SUBJECT: Docket number: 12-BTSD-06

Proposed Wall Assemblies

ConSol proposes the following additional assemblies to be added to the Joint Appendix 4 and the residential manual in order to increase diversity of wall assembly practice, give builders choices in the field, and encourage advanced construction techniques in the market as California moves toward zero energy homes.

Figure 4.x.x - Wood Framed Wall 2x6 24" o.c.

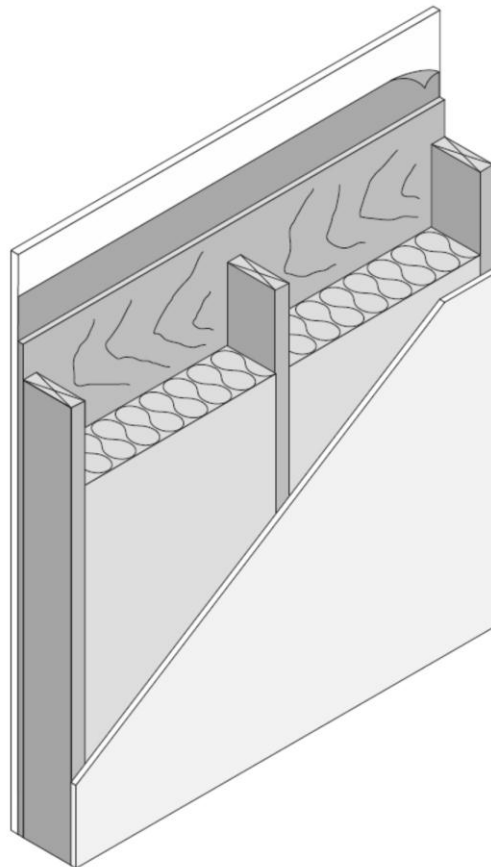
ASSEMBLY 1

Figure 4.x.x - Wood Framed Wall 2x6 24" o.c., AWF, 2 stud corner

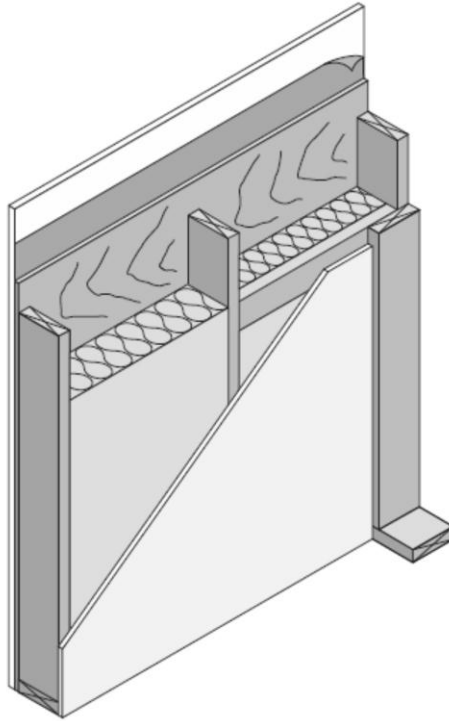
ASSEMBLY 2

Figure 4.x.x - Wood Framed Wall 2x4 24" o.c. AWF

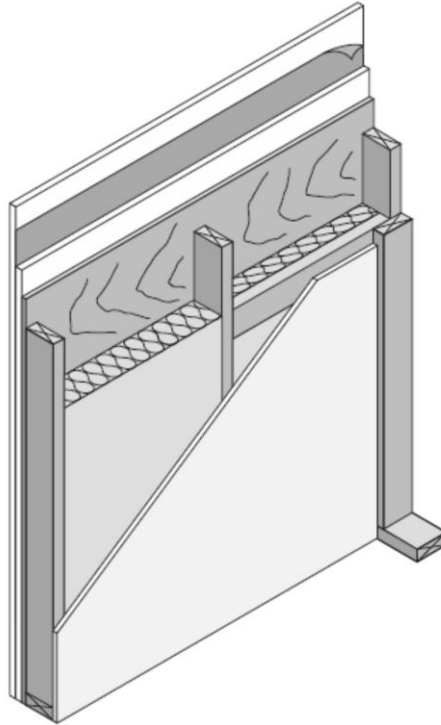
ASSEMBLY 3
